GT PCBA Testing:

TEST UWC RX Carrier Wave Off

Test failed of 6 pcs in factory.

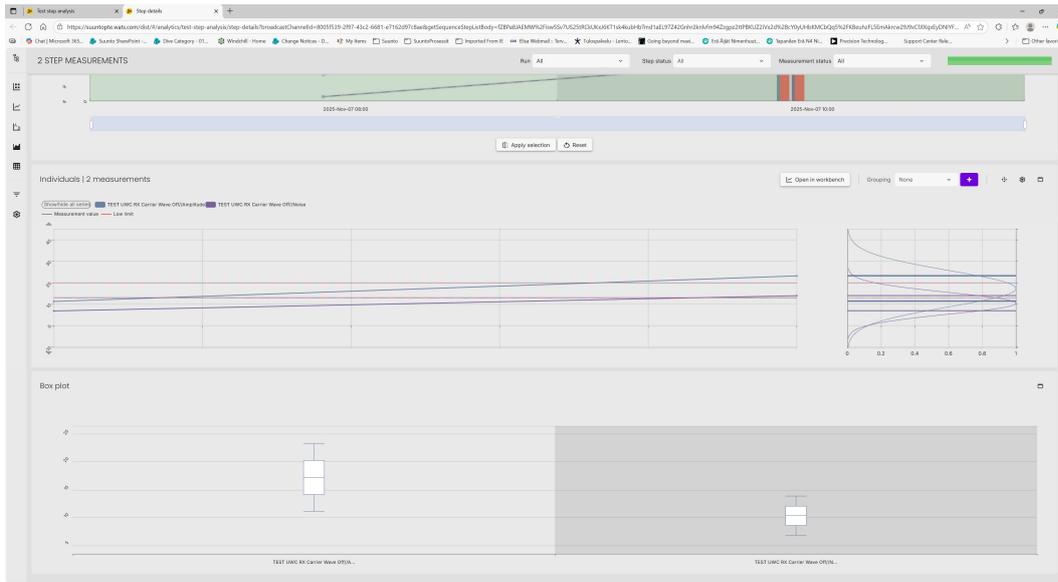
Amplitude: FIN = 23.5 CHN=26.25 +12.8%

Noise: FIN 14 CHN = 15.75 +12.5%

There is some difference between testers but is not the root cause for the failures.

2523D00021 OK card -> failed after U44 swapped from failed card

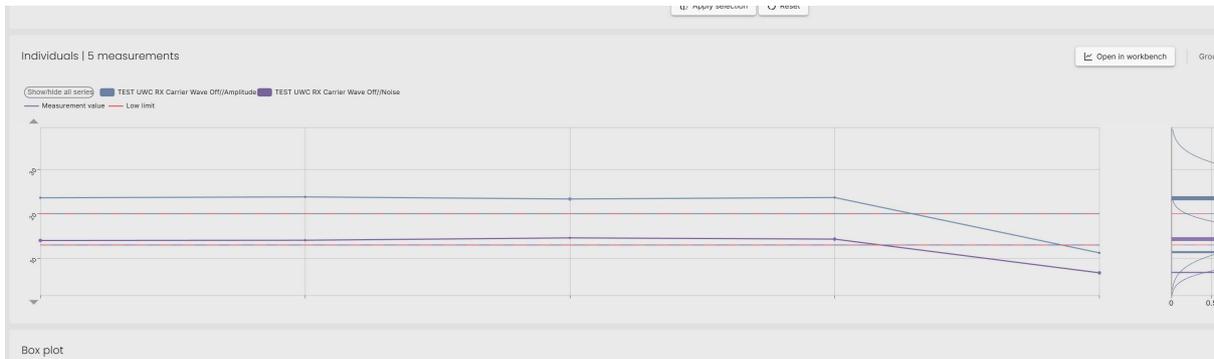
Previously replacing the U44 OPA8235 has been the solution and is also tested this time

Ok GT pcba from where the OPA2835 was swapped from 2539D00778

2539D00778 failed card -> ok after I44 swapped from ok card

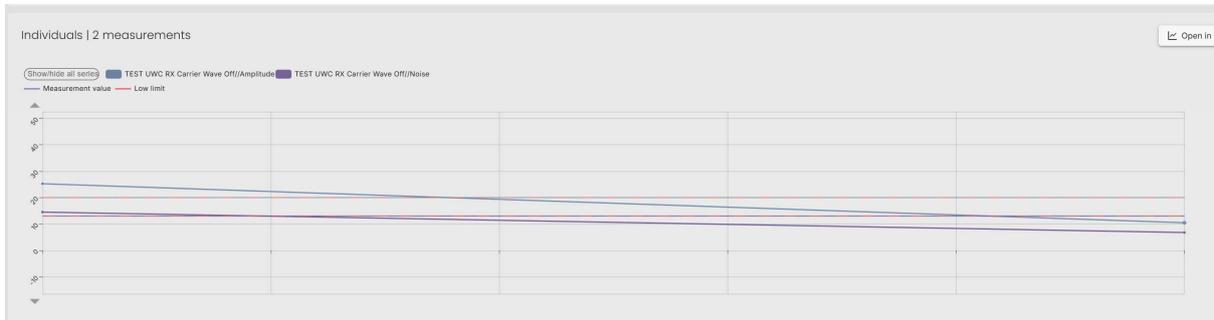
Card 2539D00778 after replaced with OPA2835 from card 2523D00021

2539D00003 failed card -> ok after U44 swapped

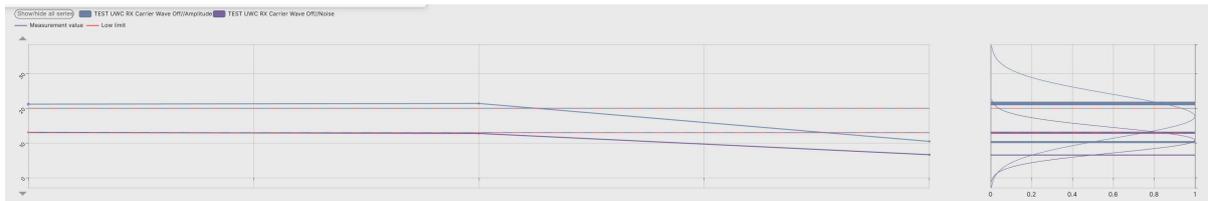
Card 2539D00003 after replaced with new OPA2835

Noise value change by replacing the OPA2835 U44

1. Replacing failed unit U44 from ok unit caused the failure to follow the U44 chip (1pcs).
2. Replacing U44 will get failed card to pass the test (2 pcs)
3. TEST UWC RX carrier wave off – test Amplitude and Noise failures are caused by U44 chip noise.
4. To rework, replace U44 :
190000385 IC OPA 31MHZ QFN10 OPA2835IRUNR TI
5. Retest the card.
